CORRIGENDUM
ADDENDUM No.02_ Dated 16.01.2017
To
Tender No. SDG3314P17/09

This Addendum No.02 dated 16.01.2017 to **Tender No. SDG3314P17/09** for supply of **Drill Pipes** is issued to amend technical specification clause no AA.A.XV of Annexure-I as under :

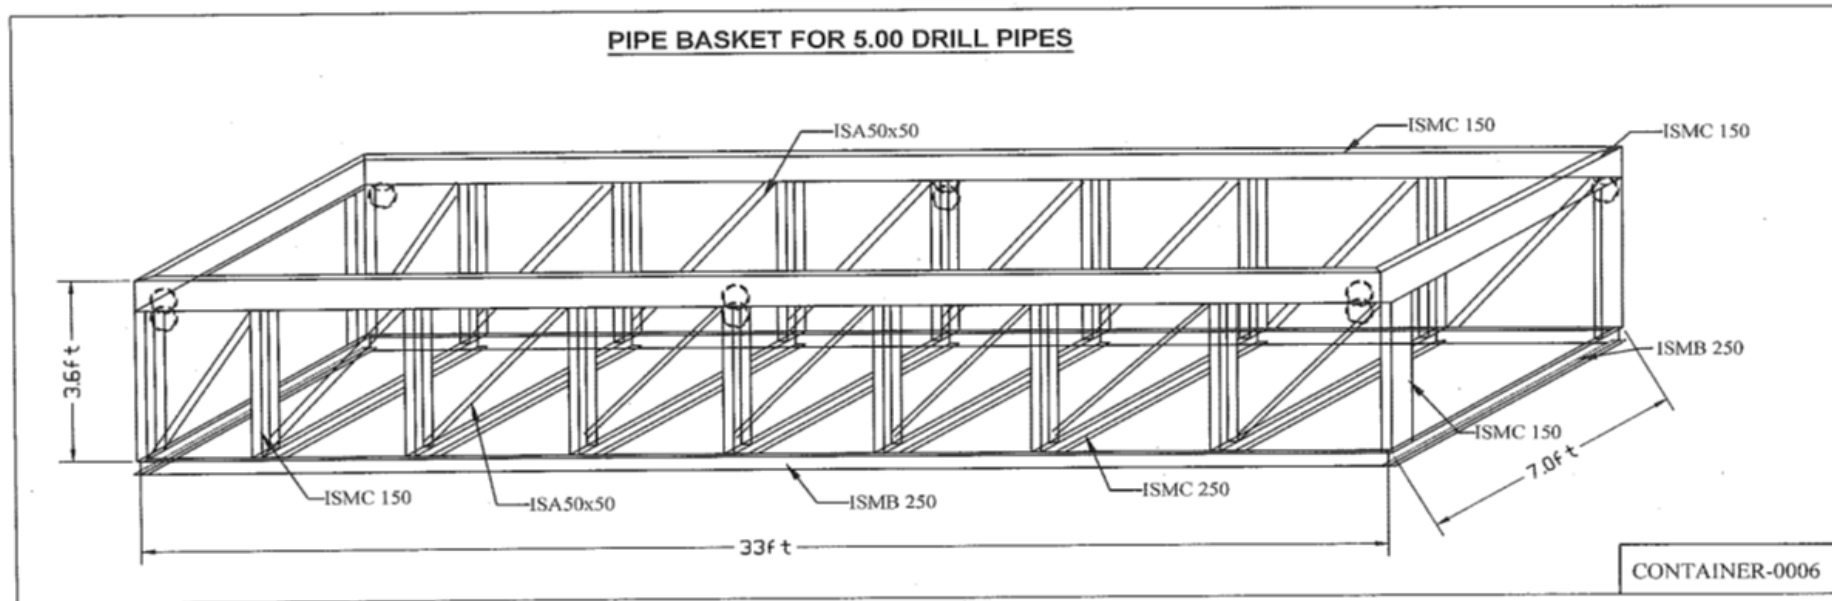
AA.A.XV :: The Drill pipes are to be supplied in Drill pipe baskets. The weight of the Drill pipe basket including the drill pipes are to be limited to a maximum of 23MT (Transport Limitations) per drill pipe basket. The dimensions of the drill pipe basket is as under and are to be manufactured and supplied as per the specifications as mentioned in the figure.
